**SUBDIVISION FINAL PLAT APPLICATION FORM
HOPKINS COUNTY, TEXAS**

Proposed Name of Subdivision: RYNN ESTATES

The preliminary plat for Mrs. Margaret Rynn 2878 FM 2297 Sulphur Springs Texas 75482 has been reviewed in my office. Upon the review with the Hopkins County Fire Marshal's office and Mrs. Rynn we have agreed upon these revisions:

Master Meter Installation

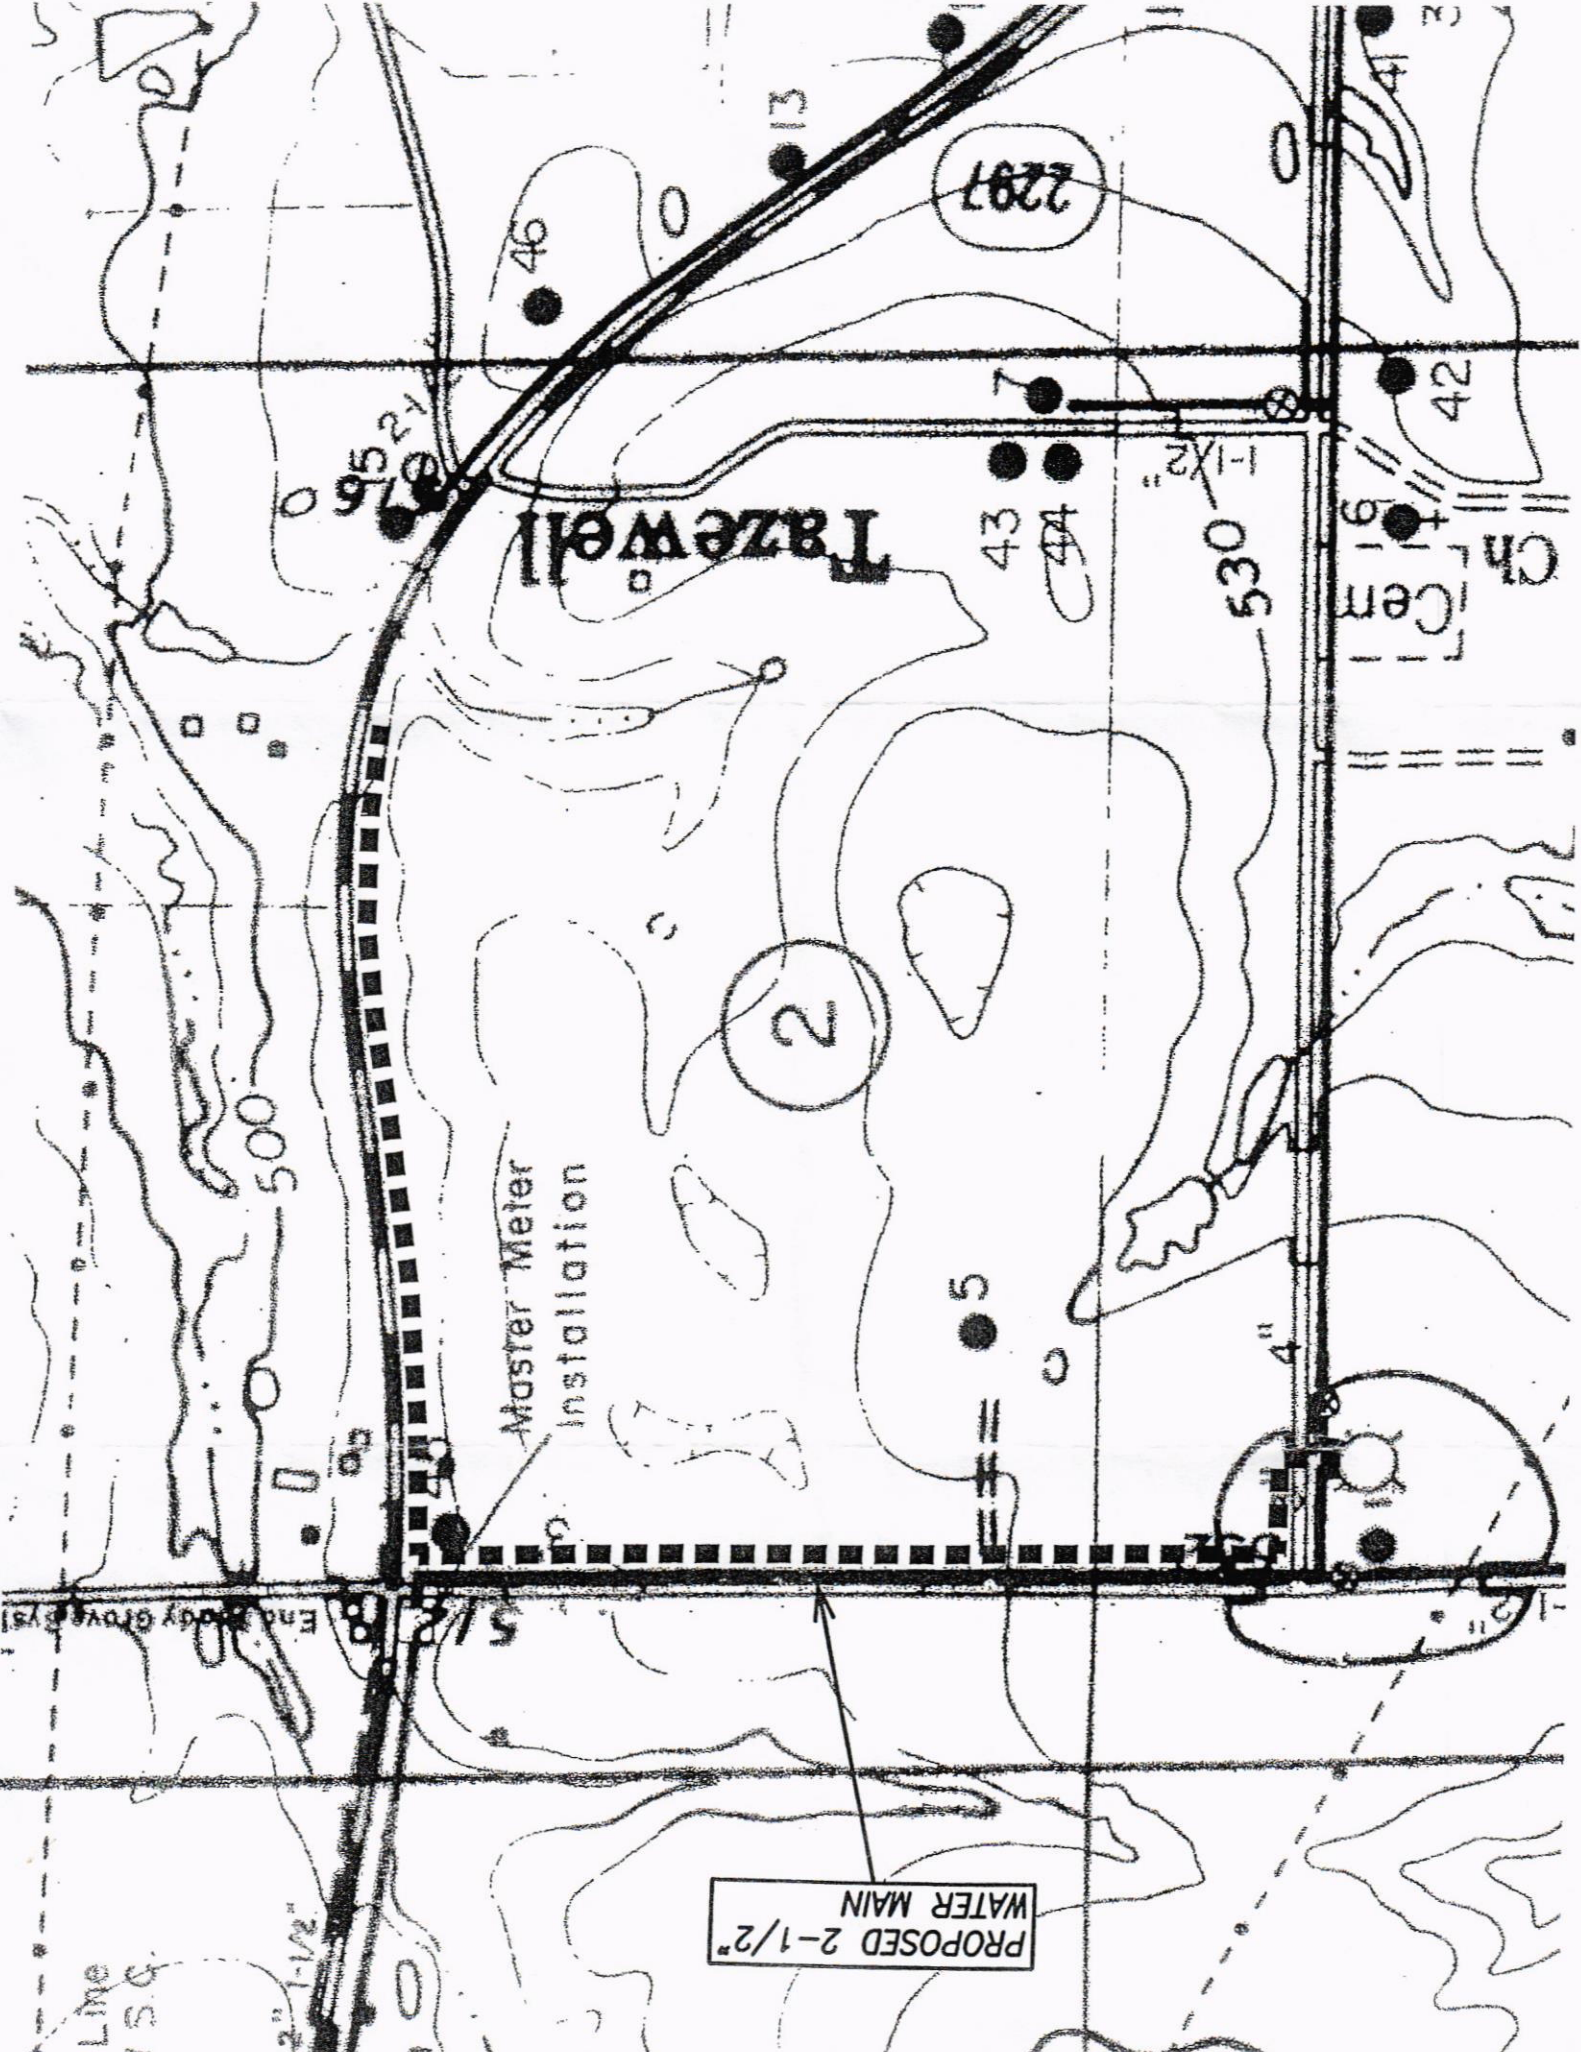
- 1) A fire hydrant be placed in the center part of the said proposed plat on or near the middle of lot 8 and lot 9 for fire protection.
- 2) If line one is not able to be obtained due to the rural water system ,then a dry hydrant must be installed on the property with an all-weather road and 24 access area.
